The Secretary
NSW Department of Planning, Industry and Environment

20 July 2020

I refer to the Department's below email of 18 June 2020 regarding Environment regarding State Significant Development SSD-10425 Tallawong Station Precinct South - Stage 2 detailed design application at 1-15 & 2-12 Conferta Avenue, Rouse Hill (Lots 293 & 294 DP 1213279) in the Blacktown LGA. Submissions need to be made to the Department by 22 July 2020.

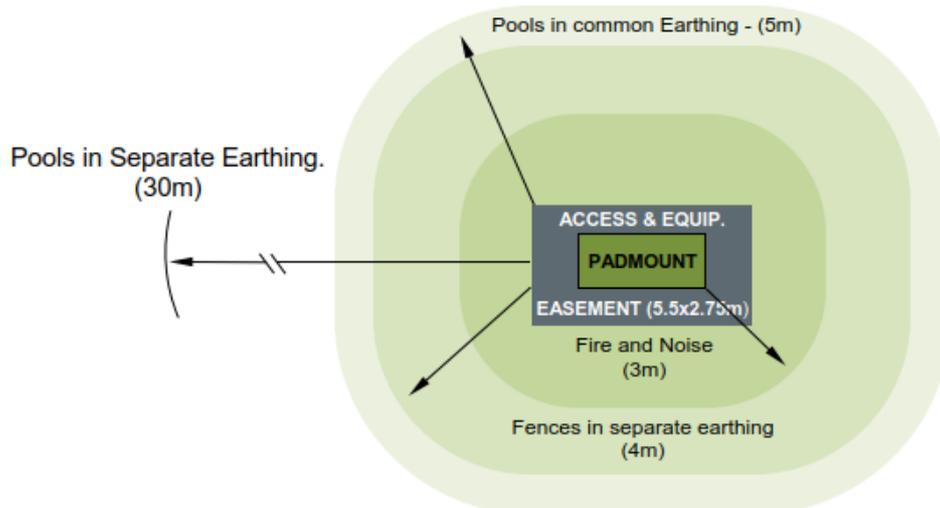
We have assessed the most recent drawings (from Rev S of the latest architectural drawings) and an A/C load of 13 Amps per apartment (advised by mechanical consultant). We have applied a diversity factor of 0.8 which is generally a conservative diversity factor for residential loads.

By adjusting the diversity factor, it limits the flexibility of increasing the electrical load of final selection of equipment and architectural changes.

FIGURE A5 FLOOD LEVEL DIFFERENCE – 1% AEP

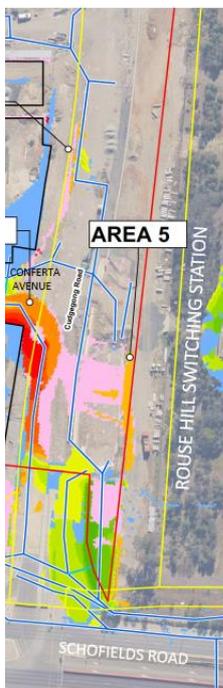
Whilst the Flood Impact Assessment does address the likely flood impacts on ‘Area 5 – Council Owned SP2 Lands’ being the area east of Cudgegong Road, it does not appear to specifically address the Rouse Hill Switching Station site which is also located to the east of Cudgegong Road. The Assessment indicates there will be post development impacts which are deemed to be considered to be acceptable. However, it is imperative that as a result there is no worsening of the existing flood impacts on the nearby properties / existing development. Reducing the effectiveness of flood conveyance or flood storage areas increases the risk of property damage to other parties – which is of particular concern for the Rouse Hill Switching Station. This issue needs to be specifically addressed and Endeavour Energy should determine if any impacts are considered to be acceptable to the Rouse Hill Switching Station.
